Addendum No. 7
OSWWTP Phase 1 Replacement Project
Corolla, Currituck County, North Carolina
July 3, 2015

WW8

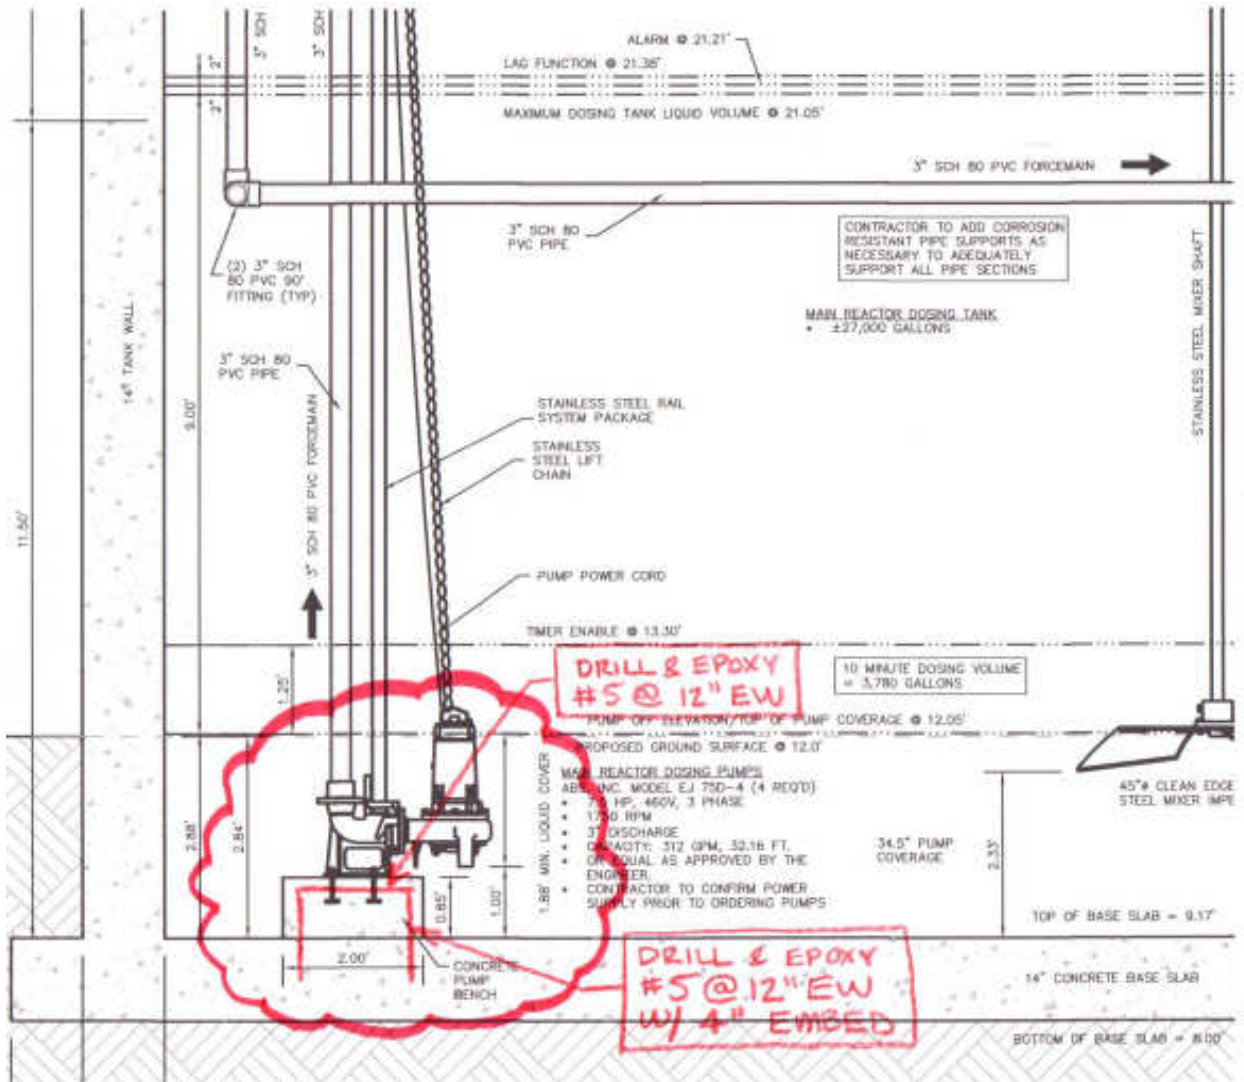
3. A concrete "bench" having the approximate dimensions of 9'L x 2'W x 0.85'H shall be added to the floor of the Main Reactor Dosing Tank to support the Main Reactor Dosing Pumps and to elevate the pump intake to be approximately 12" above the floor of the tank bottom. This bench is to be constructed at the time that the pumps, rails and discharge piping is being assembled in order to ensure the proper placement of the bench. Please see the sketches which are modifications to plan sheets WW2 and WW8.

- Drill & Epoxy #5 @ 12" EW
- Drill & Epoxy #5 @ 12" EW w/ 4" Embed
